ADDENDUM #2

Reference: Cafeteria Rooftop Unit Replacement – Rampton Building
Department of Transportation – Taylorsville, Utah
DFCM Project No. 07237900

Project Name: Cal Rampton Rooftop Replacement

DFCM Project # 07237900

HW COIL PIPING DETAIL - ADDENDUM #1

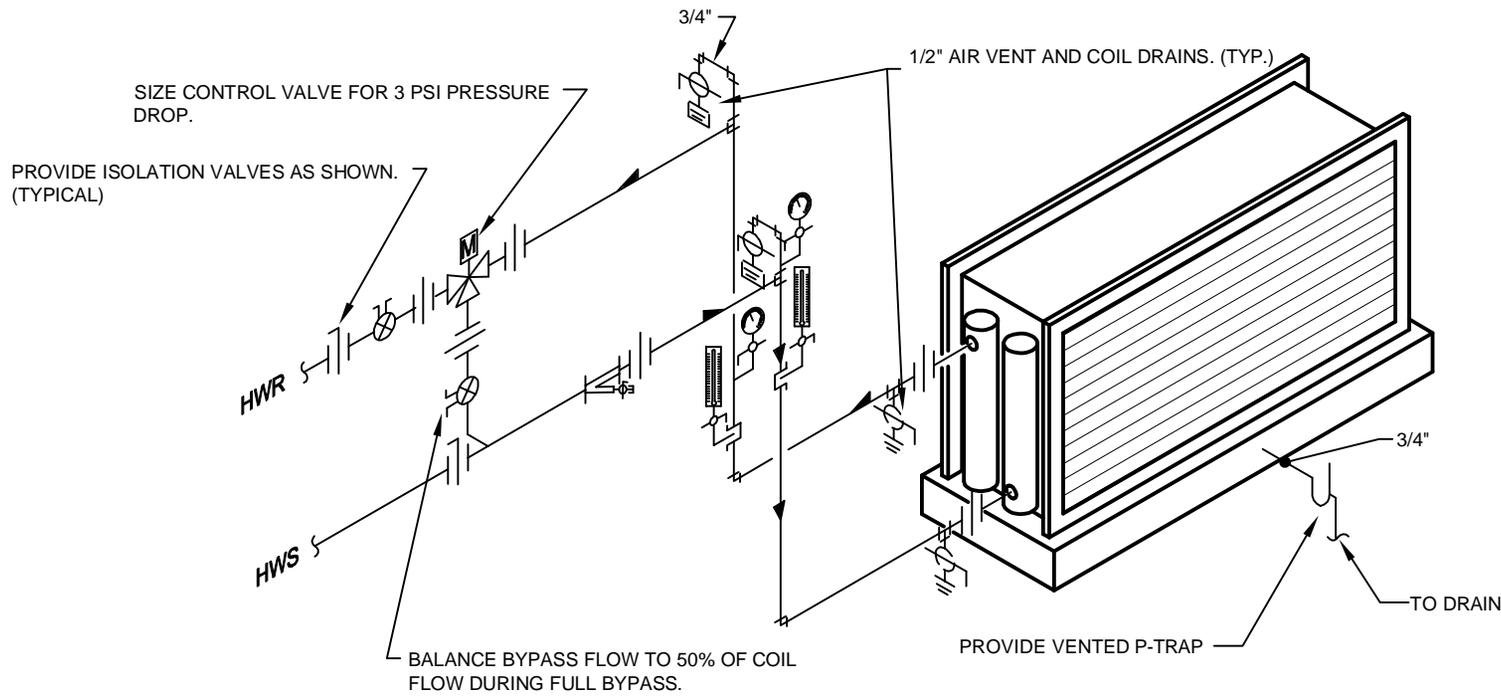
Item VI-1. Detail A2/ME601: The hot water piping from the roof to the coil, along with the coil connection will need to be made by this contractor. All sizes, duct locations, piping locations, etc. shall be field measured within 1 week of receiving a contract, prior to providing rooftop submittals. See attached hot water coil piping detail ME601A.
